File Number: 6-C-25-IH

Meeting: 6/18/2025
Applicant: Eric Forrestall Bald Design Services
Owner: Osuma Homes LLC
District: Lonsdale Infill Housing Overlay District

Location: 0 Ohio Ave. **Parcel ID:** 81 | C 029
Zoning: RN-2 (Single-Family Residential Neighborhood)
Description:
New primary structure.

Level III New Primary Structure

1 ROOF PLAN
1/4" = 1'-0"

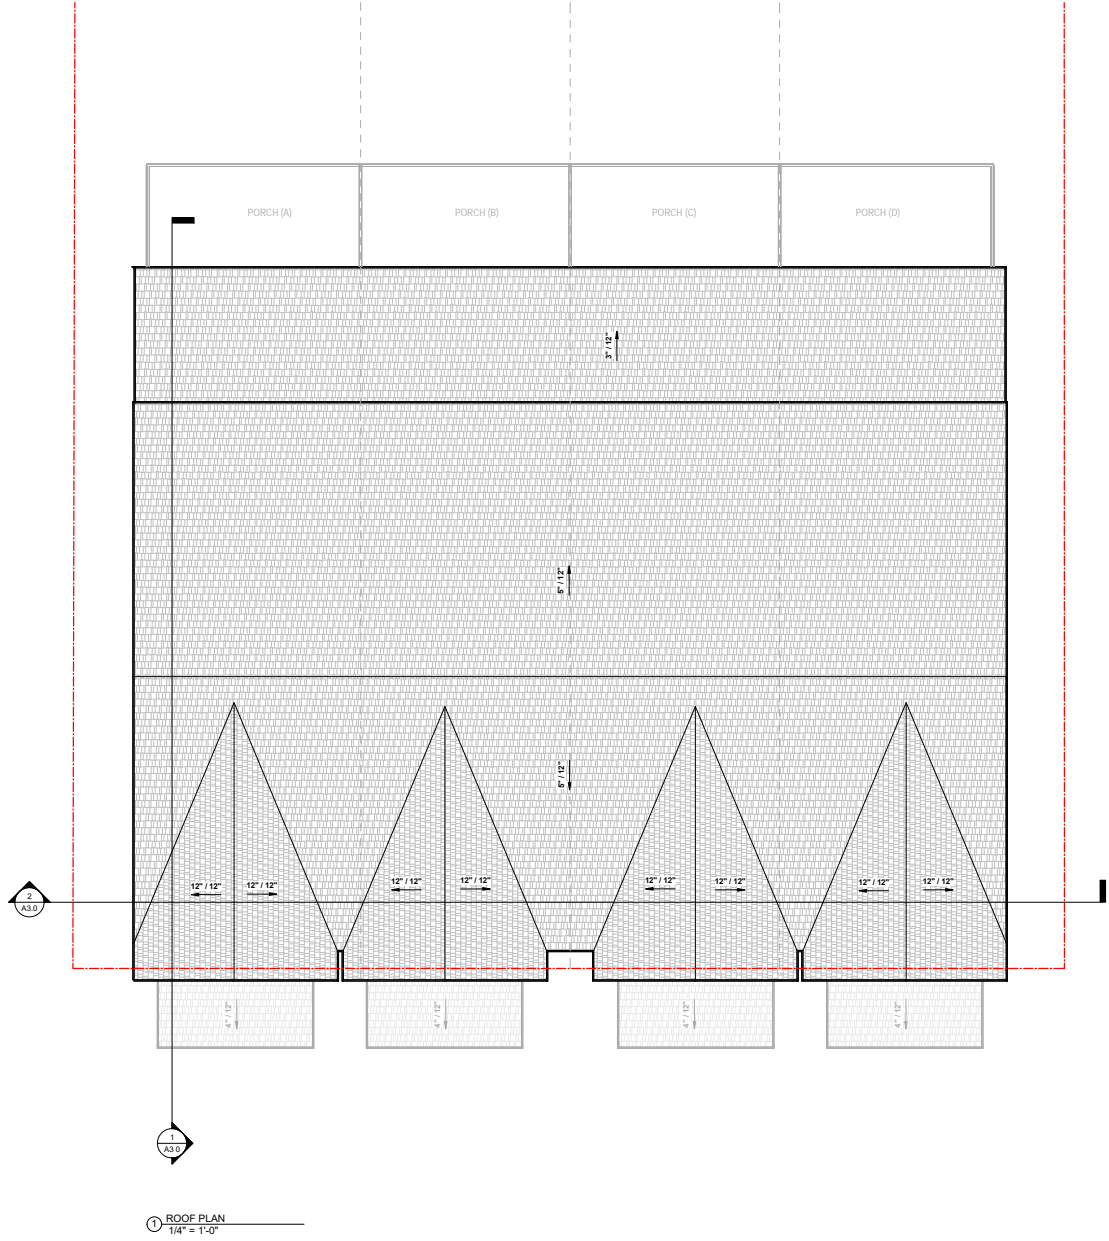
11. At least a 6/12 roof pitch is required in the Middle Housing standards to fulfill the "steep" category of roofline; 6/12 is also the minimum pitch recommended by the DRB. The roof pitch should be increased to at least 6/12.

2 RIGHT SIDE ELEVATION
1/4" = 1'-0"

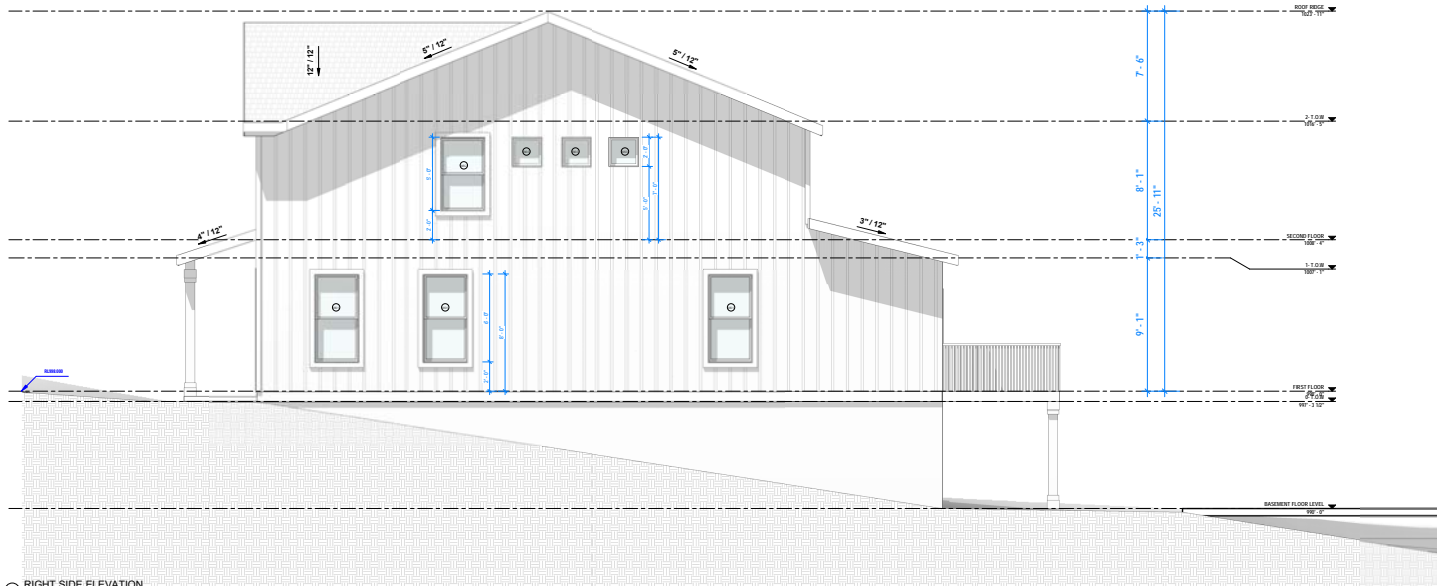
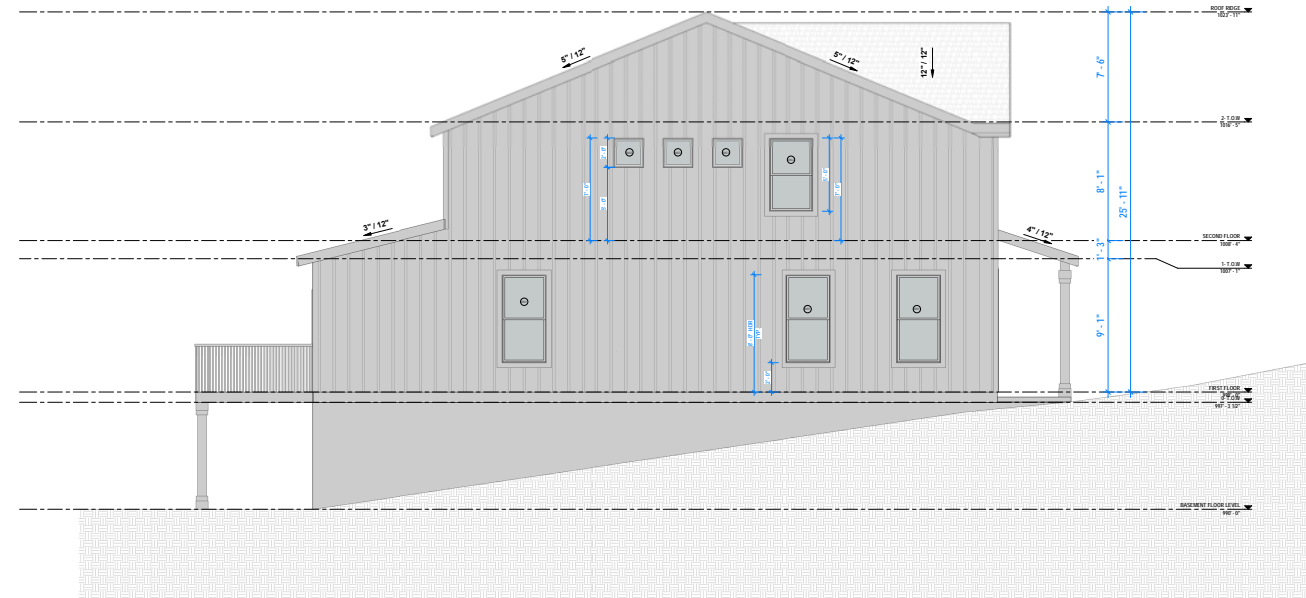
10. Guidelines recommend that windows and door styles be similar to historic houses on the block, with similar proportions and positioning, and similar ratio of solid to void. The proposed single-hung windows and half-light paneled door are compatible with the context. The location of the single-hung window on the second story, side elevations should be aligned above the window on the first story. The slider windows on the rear elevation and small fixed windows on the side elevations are not compatible with historic window forms; revisions should be made to the side elevation window patterns to address the three fixed windows.

Staff recommends approval of Certificate 6-C-25-IH subject to the following conditions: 1) meeting all relevant standards of Articles 4.6 and principal use standards, with minor related revisions to be approved by staff; 2) revisions to front setback to meet Article 4.6; 3) revisions to side elevation window design and placement; 4) roof pitch to be revised 6/12 or steeper; 5) siding to be clapboard-style lap siding with an overlap, as opposed to Dutch lap, flush panel, or board-and-batten siding; 6) the final site plan to retain the existing trees as much as possible, including at least one tree in the front yard; 7) final site plan to meet City Engineering standards, with the overall parking area to be reduced in size and access to meet the design guidelines, with major changes to site plan to return to the Board for review; 8) the new subdivision plat to meet Subdivision Regulations, with any major revisions to return to the Board for review.
